Addendum # 2

St. Thomas Mission House Remodel
919 Indiana Ave.
Coeur d'Alene, Idaho 83814

From: Miller Stauffer Architects, PA.
601 E. Front Ave. Suite 201
Coeur d'Alene, ID 83814
Ph (208) 664-1773
Fax (208) 667-3174
Website: www.millerstauffer.com

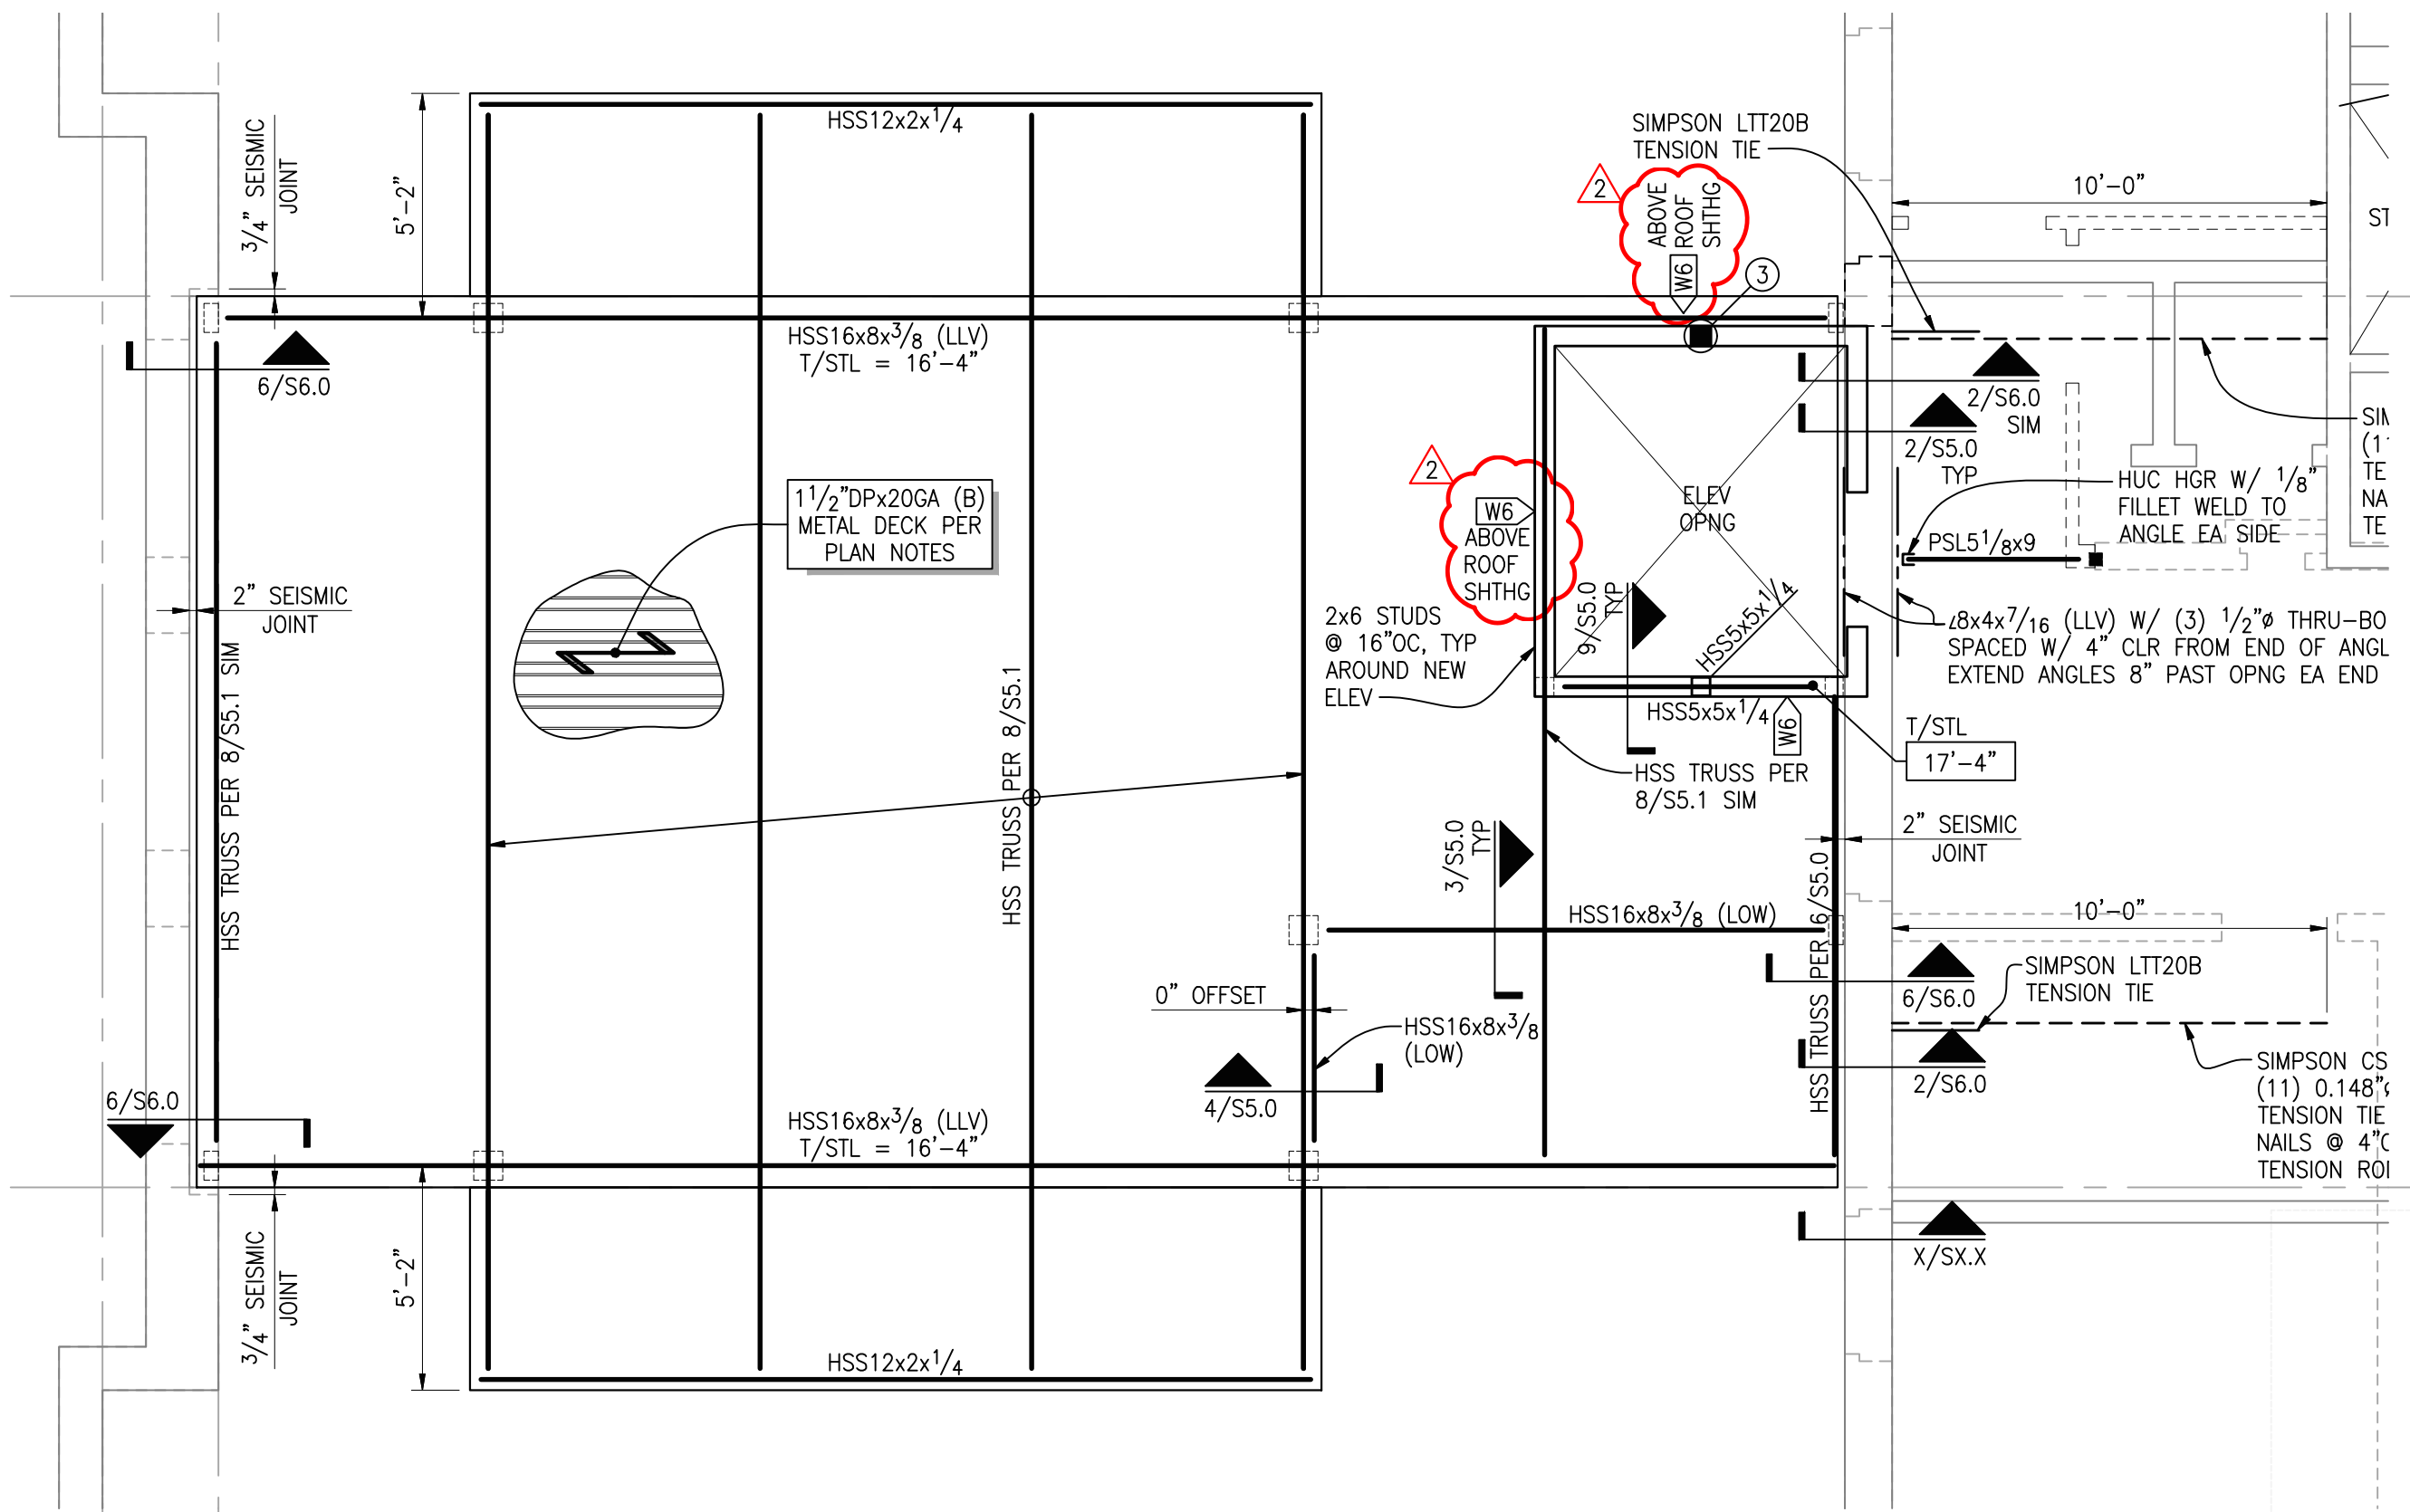
- A. S3.1 – Revised T/Conc wall elevations & column connections. Reference CS-01.
- B. S3.3 – Added note that shear wall applies only above roof. Reference CS-02.
- C. S4.1 – Added detail 6 & 10. Column connection to slab and stem wall. Reference CS-03 and CS-04.
